**LAKE PONTCHARTRAIN, LOUISIANA AND VICINITY
CHALMETTE AREA PLAN**

**BAYOU DUPRE CONTROL STRUCTURE
PERIODIC INSPECTION REPORT NO. 6**

CELMV-ED-GS (CELMN-ED-DG/15 Aug 90) (1105-2-10c) 3d End
Mr. Cave/jl/601-634-5897
SUBJECT: 1990 Periodic Inspection Report No. 6 for Bayou Dupre
Control Structure

PHOTO 3: CORROSION OF METAL HATCH ON TOP OF THE SOUTH END OF THE EAST GATE MONOLITH. NOTE CONCRETE SPALLS DUE TO EXPANSION OF THE METAL.

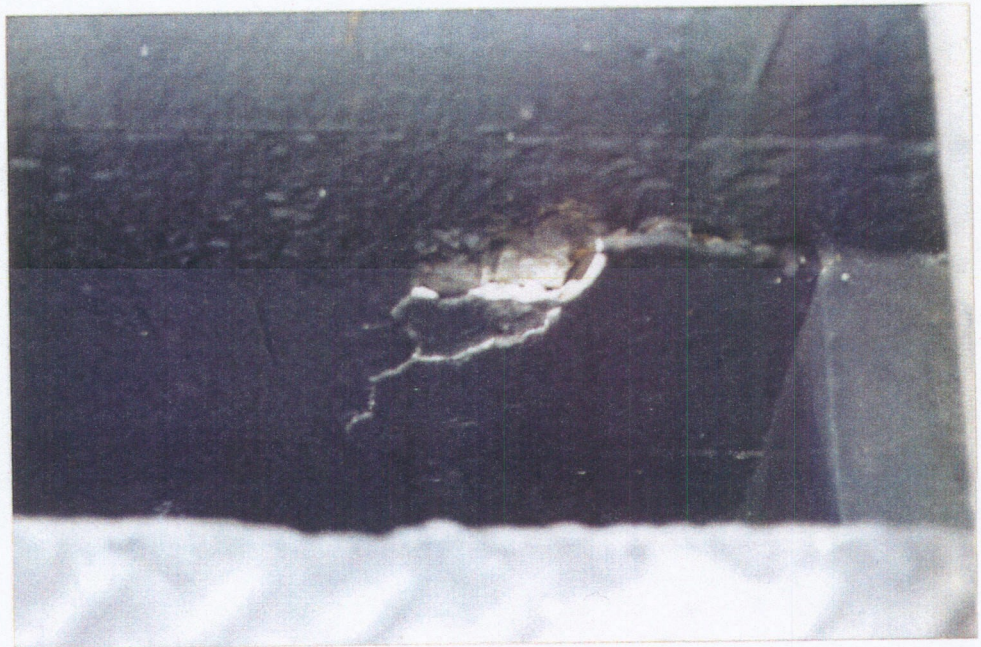
a. Para 6-02a.(3) and Photo No. 3. The rusted portion of the metal hatch should be cleaned and painted and the concrete repaired as required. Continuing to "monitor" the problem will only result in a worse condition in another year or so.

a. Para. 6-02a.(3) and Photo No. 3. Concur. Para. 6-02a.(3)
has been revised. Three copies of revised page VI-1 are submitted
for your files (see encl 2).

(3) The rusted portion of the metal hatch on top of the east gate monolith (shown in Photo No. 3) will be cleaned and painted and the concrete repaired by LBBLD.
